City of Tacoma

Questions and Answers

Multilingual Street Signs Project RFQ Specification No. PW24-0253F

- **Adopt A Spot**
- **Traffic Circle**

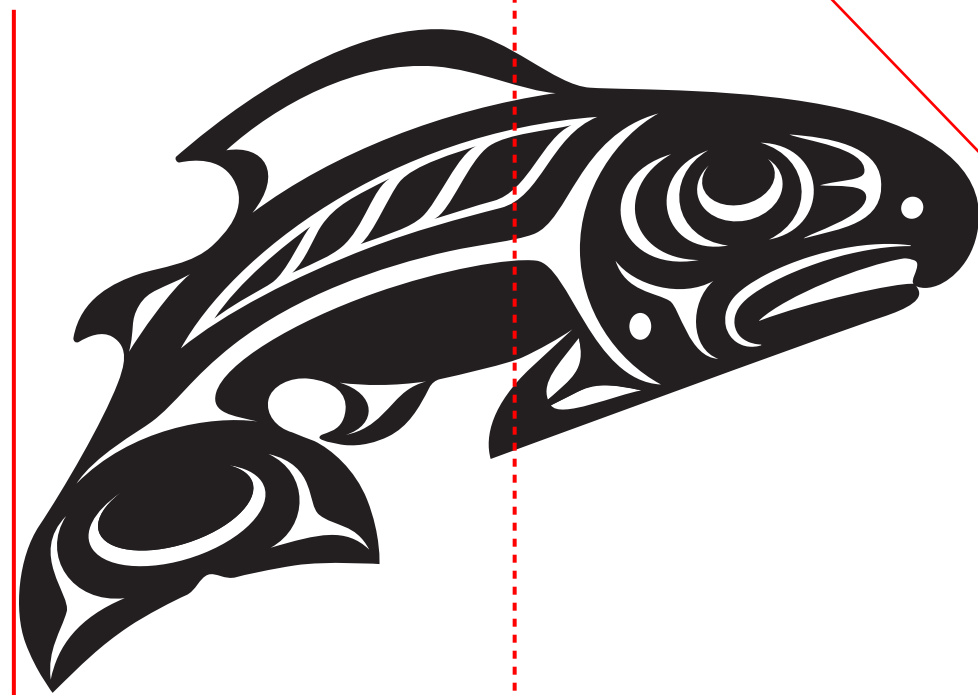
6. Question: What are the Sizes of the signs listed below:

Answer: Adopt A Spot sign is - 24"x24" and the Traffic Circle sign is 18"x18". Please see attached graphics for their layout.
